Core Bus Corridor 4: Finglas - Preliminary Submission

2.6 Buffer Space

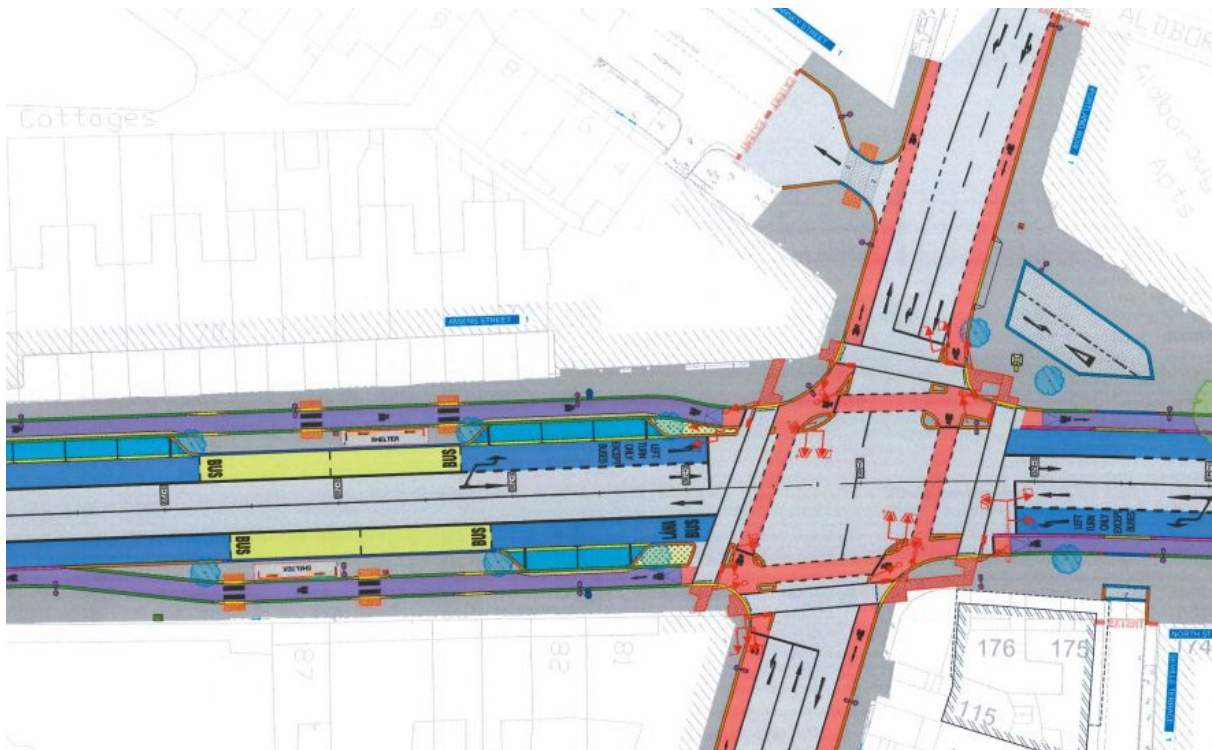
The NTA's own National Cycle Manual (NCM), section 1.7.4, recommends that there should be a buffer space of either a hard paved area or grass verge between the cycle track and the roadway when the AADT and 85th percentile speeds are both high. This needs to be considered and ideally adhered to.

Figure 7.6 Cycle Gate

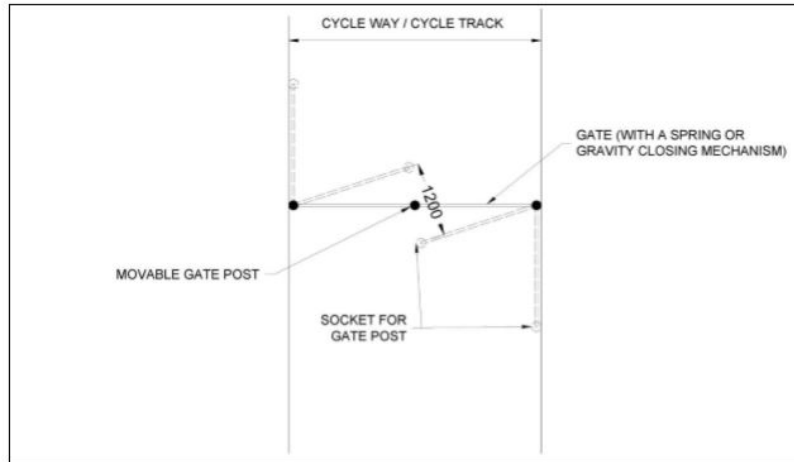
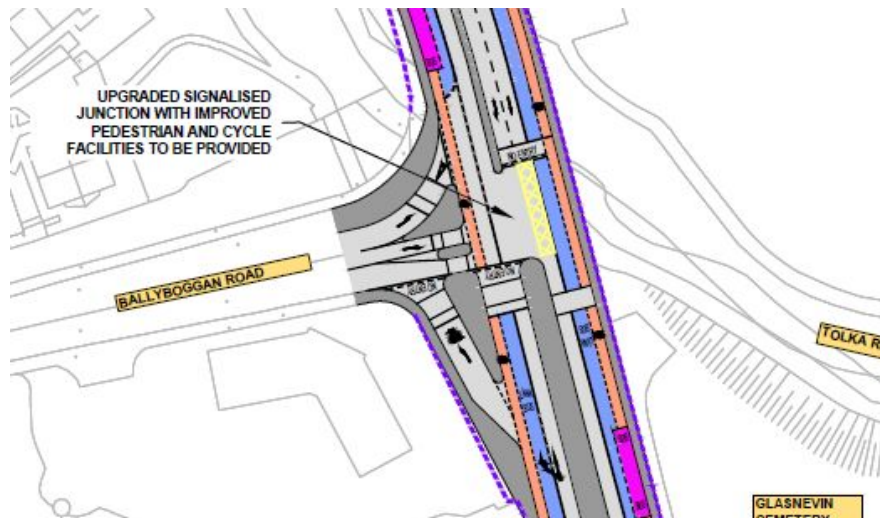
3.6.6 Tie-in with Tolka Valley cycle route - The details of the links with the Tolka Valley Greenway route are critical, as this, together with the CBC improvements will undoubtedly lead to greater cycling. At the very least the access gate area to the present route westwards needs easier negotiation, and TII draft design - see below - should be considered.

Bike filter to Ballyboggan rd

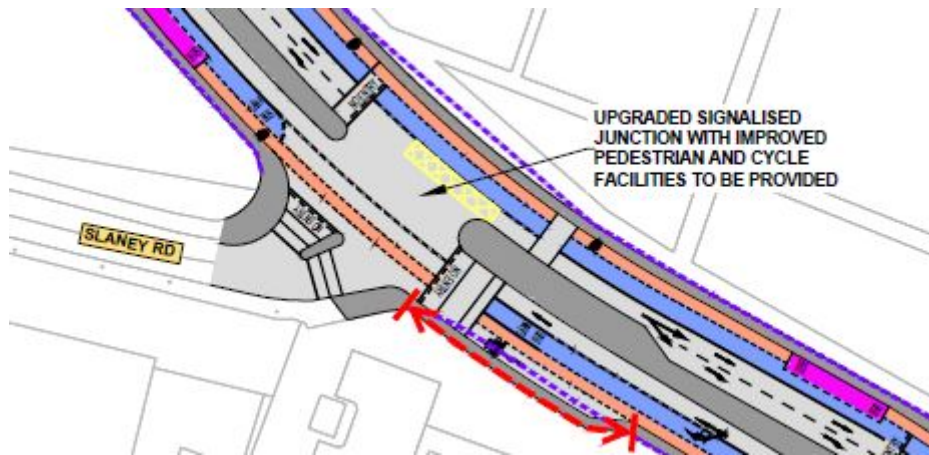
3.6.7 Ballyboggan Road junction - similar to statements above, we would like to see bike lanes extended on to Ballyboggan road, ASL at junction, and clear protection for cyclists from left turning outward bound traffic.

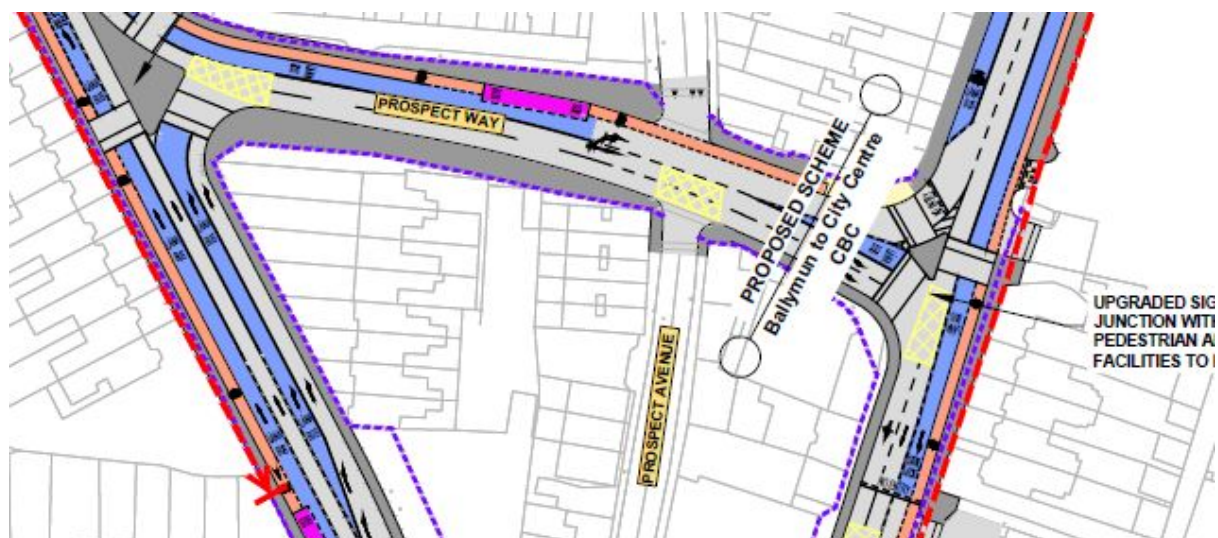
This area needs serious protection for cyclists, in a very tricky fast flowing traffic situation. We suggest a number of ideas for consideration:

1. Remove 5 parking bays south of Dalcassian Downs to ensure continuity of bus and cycle facilities through this area.
2. Consider contra flow cycling route through Prospect Avenue northwards to link with Botanic Road/Ballymun Scheme
3. This contra flow route to be complemented by well designed toucan crossings at Prospect Way, and at the southern Phibsborough end
